Access Compliance Report

Public Rights-of-Way

Intersection ID: 16439	Main Street: SOUTH_BV	Cross Street: SCALEYBARK_RD	Location: SW
ADA ID: D9F4A6A52DD5	Ramp Type: Perp	Initial Pass/Fail: Fail	Overall Compliance: No
			Severity Score: 26.25

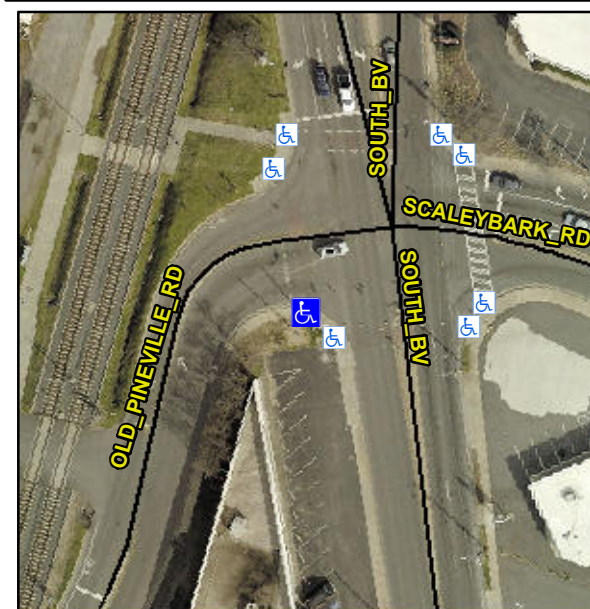
Not Found, R304.2.2

Compliance	Description	Data	Compliance	Description	Data
N/A	Ramp Length (in)	58.0	No	Ramp Slope (%)	12.9
Yes	Ramp Width (in)	48.0	Yes	Ramp XSlope (%)	2.8
N/A	Flare Type LT	N/A	N/A	Flare Type RT	N/A
N/A	Flare Slope LT (%)	N/A	N/A	Flare Slope RT (%)	N/A
N/A	Flare Traversable LT?	N/A	N/A	Flare Traversable RT?	N/A
N/A	Landing Length (in)	N/A	N/A	DWS Provided?	N/A
N/A	Landing Width (in)	N/A	N/A	DWS Contrast?	N/A
N/A	Landing Slope (%)	N/A	N/A	DWS Length (in)	N/A
N/A	Landing X Slope (%)	N/A	N/A	DWS Full Width?	N/A
N/A	Landing Curb? (Y/N)	N/A	N/A	DWS Offset (in)	N/A
N/A	Shared Landing?	N/A			
N/A	Gutter Ponding?	N/A	N/A	Gutter Slope (%)	N/A
N/A	Gutter Lip Ht (in)	N/A	N/A	Gutter X Slope (%)	N/A
N/A	Painted X Walk1?	Yes	N/A	Painted X Walk2?	N/A
	X Walk 1 Direction	To N		X Walk 2 Direction	N/A
N/A	X Walk 1 Width (in)	98.0	N/A	X Walk 2 Width (in)	N/A
	X Walk 1 Slope (%)	0.6		X Walk 2 Slope (%)	N/A
	X Walk 1 X Slope (%)	3.1		X Walk 2 X Slope (%)	N/A

Remove & Replace Entire Ramp.
